Question regarding **safety concerns** of the Milton Road 'Final Concept'

This Question relates to Appendix E (cross-section diagrams) of the Final Concept report from WSP, dated 05/07/2017. Specifically, the cross-section diagrams: 2012-SK-050-054 (the two diagrams labelled "Gilbert Rd Approach"):

Diagram (I)

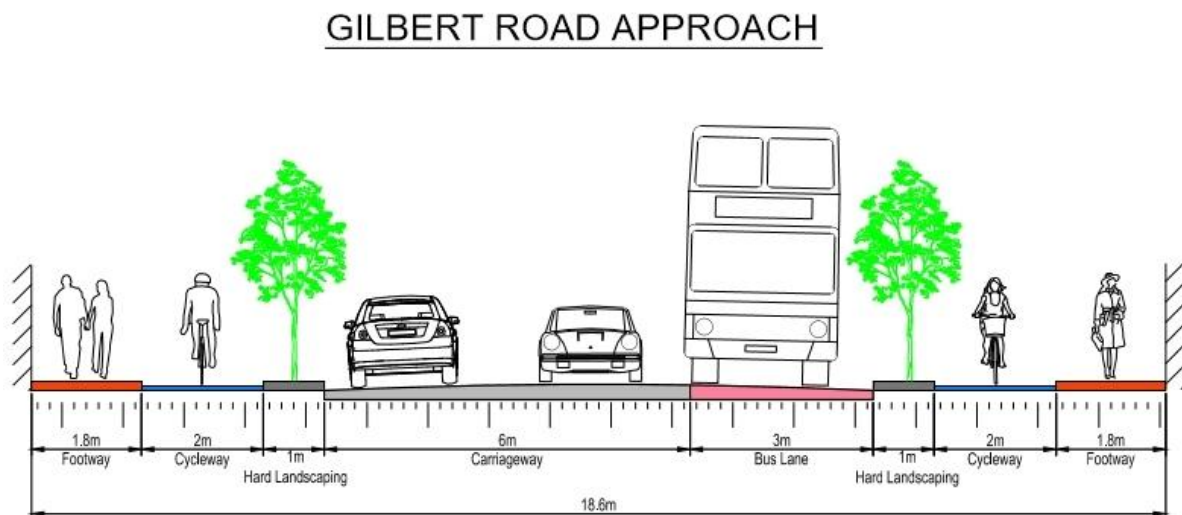
From Diagrams (I) and (II) it is clearly evident that if one adds in the vehicle wing mirrors, then 3m-wide lanes would **not be wide enough** to support 3 vehicles of bus-width passing alongside each other. To avoid an accident there is a danger in Diagram (II) of a bus veering into the cycle lane (easily mounting the verb) and fatally injuring a cyclist, or forcing a cyclist to veer into the pedestrian walkway and injuring a pedestrian.

Observation: A tree/verge barrier as in Diagram (I) separating traffic from stylists **is essential for the safety** of both cyclists and pedestrians.
